Mr. Ian C. Porter
World Bank Country Director
Lao PDR and Thailand
East Asia and Pacific Region

Re: flawed assumptions and false statements in NT2 economic appraisal

Figure 1: RELC assumptions for annual CCGT O&M costs compared with Thai and international benchmark values. (Graph of data in Table 2). Notice that RELC/2004 costs were similar to Thai and international benchmark figures, but RELC costs are more than twice as high as the highest benchmark.

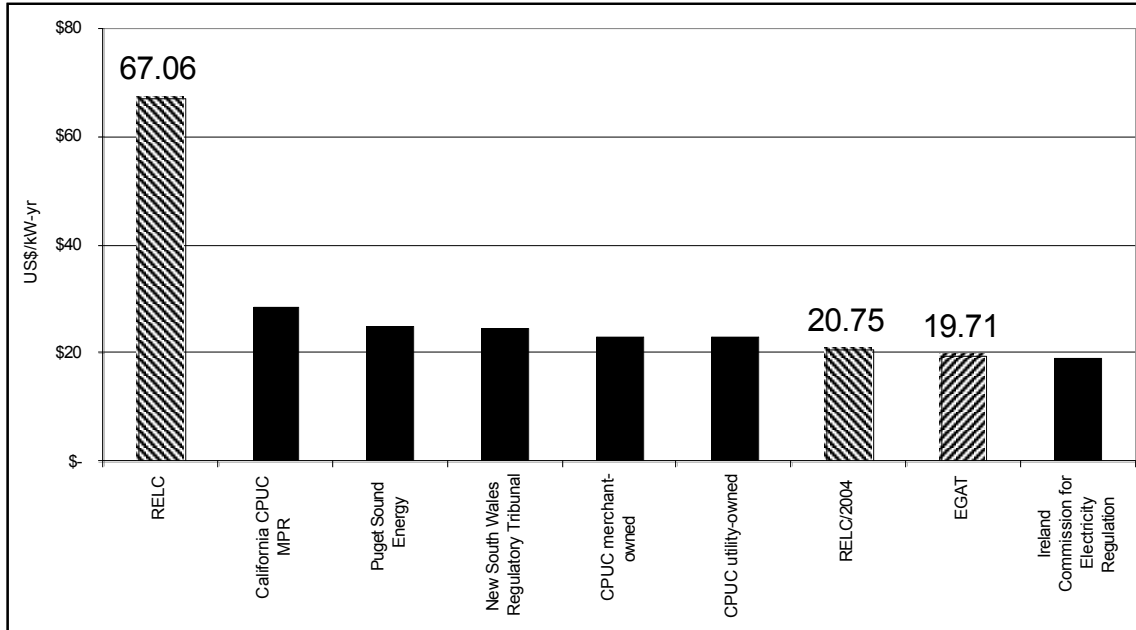
Perhaps the most startling feature in Table 2 (graphed in Figure 1) is that the RELC O&M values are by far the highest values in the table. Though we conducted an extensive internet search of CCGT O&M costs, *we were unable to find O&M costs anywhere in the world that were even half as high* as those assumed in the RELC. To the best of our knowledge, these cost estimates all include insurance, inspection and maintenance. In addition, the international benchmark values are generally *commercial* O&M costs, and therefore overstate *economic* costs because they do not include profits or taxes. They cover the spectrum from utility-owned generation to independent power producers. In our international search, the highest assumptions we encountered (besides the RELC figures) were those used in avoided cost calculations by the California Public Utilities Commission (CPUC). Consider that California has extremely high labor costs and some of the strictest environmental regulations for power plant emissions in the world. We are surprised that the Bank believes that O&M costs for CCGT in Thailand, which has fairly low labor costs, would be more than twice as high as CPUC cost estimates.

Perhaps more important than the international benchmark values are the Thai EGAT values. The RELC cost estimates for total O&M are 340% as large as EGAT total O&M cost estimates. EGAT has an extensive record running CCGT in Thailand. For new EGAT plants, it seems appropriate to use EGAT O&M costs.⁸ At the same time, one would not expect EGAT costs for CCGT O&M in Thailand to be *that* different from private sector costs. EGAT typically has a larger workforce per plant than private sector Independent Power Producers (IPPs), but IPPs may pay somewhat higher salaries -- these two effects would tend to compensate for each other. Our research finds evidence that insurance costs for utility and IPP CCGT are similar and account for a fraction of total O&M costs.⁹

What can possibly explain the huge differences between RELC assumptions and benchmark O&M figures?

1. A detailed justification for the exceptionally high economic cost estimates for O&M of CCGT. Given the importance of this variable, and the radical escalation of its value in the *RELC* it deserves more than the 6-point font footnote to Table 13. Specifically, the justification should include a discussion of the conditions in Thailand that lead to O&M CCGT costs that are far above international levels and published EGAT figures.
2. An explanation of why published EGAT figures are not relevant for the *RELC* analysis.
3. An explanation for why there was no discussion in the text of the *RELC* of the 1240% escalation in CCGT and 1000% escalation in GT VOM values. We find this omission astounding considering that this change accounts for more than half of the “with NT2” savings and that the values assumed are exceptionally high by international standards.
